ATTACHMENT A

### Safety Evaluation

Proposed Change Request No. 96 amends the Beaver Valley Power Station, Unit No. 1 Technical Specifications, Appendix A concerning the interim Offsite Organization.

Figure 6.2-1  
OFFSITE ORGANIZATION (PARTIAL)

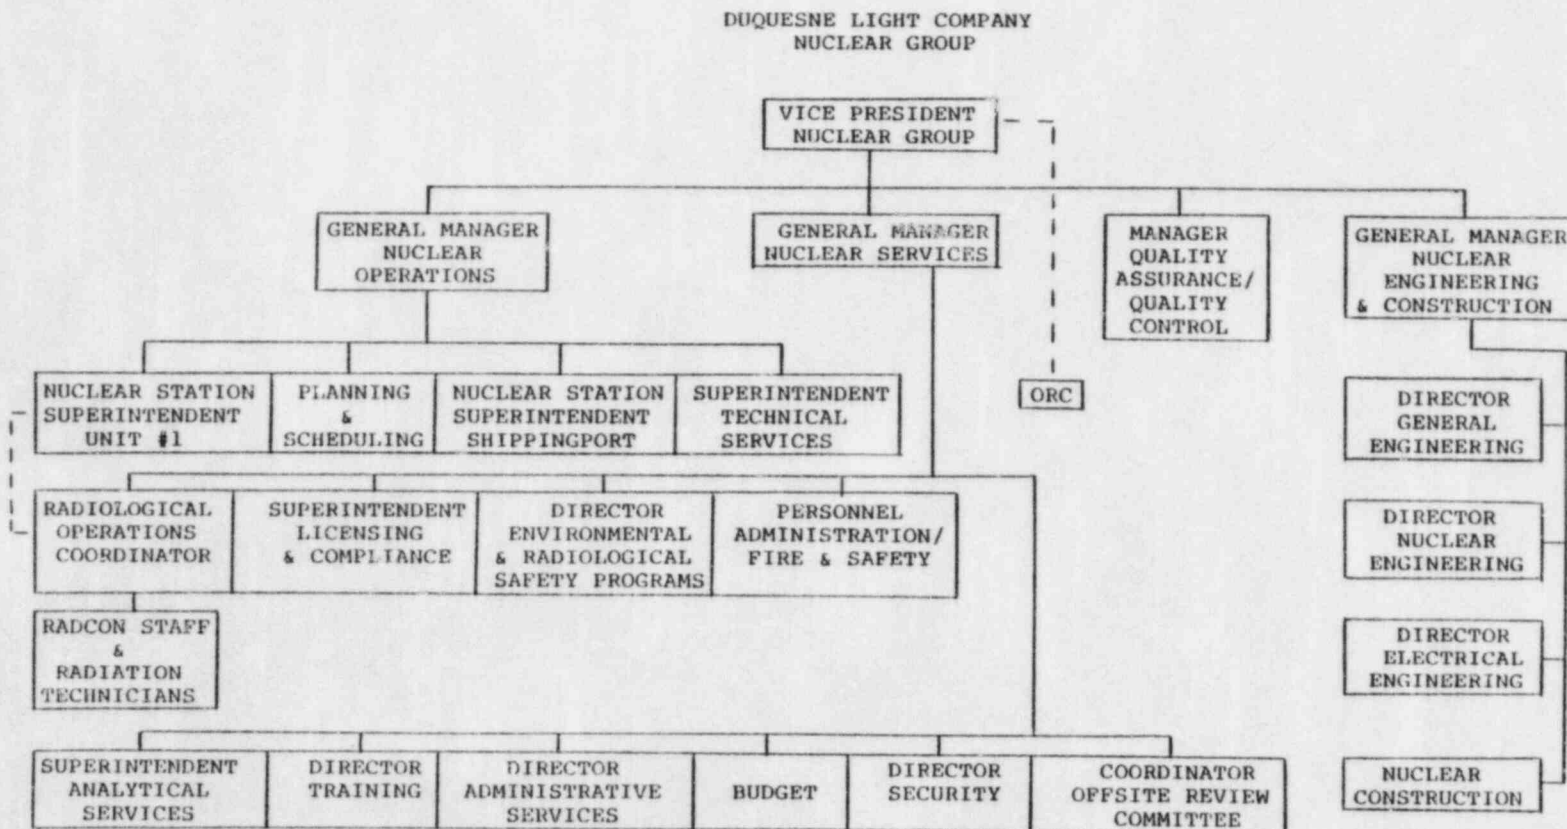
Figure 6.2-1, Offsite Organization, has been revised to reflect the interim titles changes and reporting assignments due to a management reorganization.

This reorganization consolidates the nuclear portion of the company under a single management position. Quality Assurance and Quality Control are now under the responsibility of the Manager, Quality Assurance. The Manager, Quality Assurance now reports to the same management level as the General Manager, Nuclear Operations and will continue to provide for the organizational freedom necessary for the QA program to operate in accordance with the requirements of 10CFR50 Appendix B.

The titles of all the positions reporting to the General Managers have not been determined at this time. The General Manager, Nuclear Engineering and Construction is responsible for the areas of Nuclear Engineering, Nuclear Construction, and Nuclear Engineering and Construction Support Services. The General Manager, Nuclear Operations is responsible for the areas of Operation, Maintenance, Technical Services and Planning and Scheduling. The General Manager, Nuclear Services is responsible for the areas of Licensing and Compliance, Radiological Operations, Environmental and Radiological Safety, Personnel Administration including Fire and Safety, coordination of the Offsite Review Committee, Analytical Services, Training, Administrative Services, Budget, and Security. A position responsible for the area of Special Projects will report directly to the Vice President, Nuclear Group.
